Contractor Queries for Bid No: RFP/002/2025: External Bulk Electrical

4.8. The switchgear for S1 Substation Erf 4.

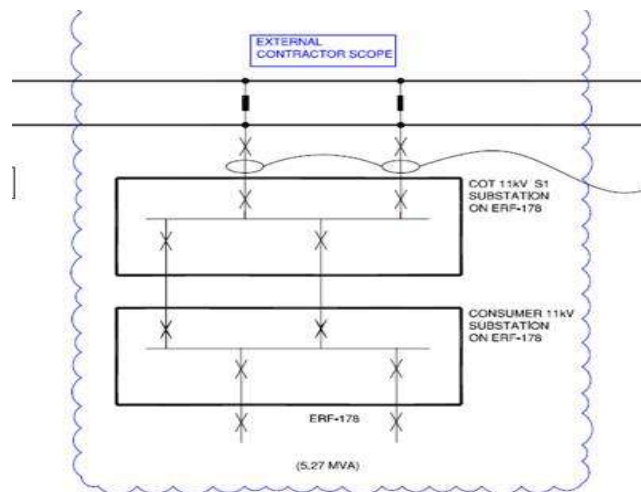
- 4.8.1. Does this switchgear have to be Actom switchgear as it is not connecting to an existing Actom board?
- 4.8.2. What are the amperages for the 8 panels?
- 4.8.3. What are the CT ratios required?
- 4.8.4. What protection is required in each panel type?
- 4.8.5. Are they 2 separate boards as per the image below with 4 incomers and 4 feeders?

4.8.5.1. TASEZ Response: As noted on the tender & bill documents that Actom are the "only" preferred suppliers/manufacturer of the MV switchgear panels and are fully aware of the CoT standards requirement needed for these panels. It's the responsibility of the contractor to provide this information aligning with Actom as the preferred supplier/manufacturer.
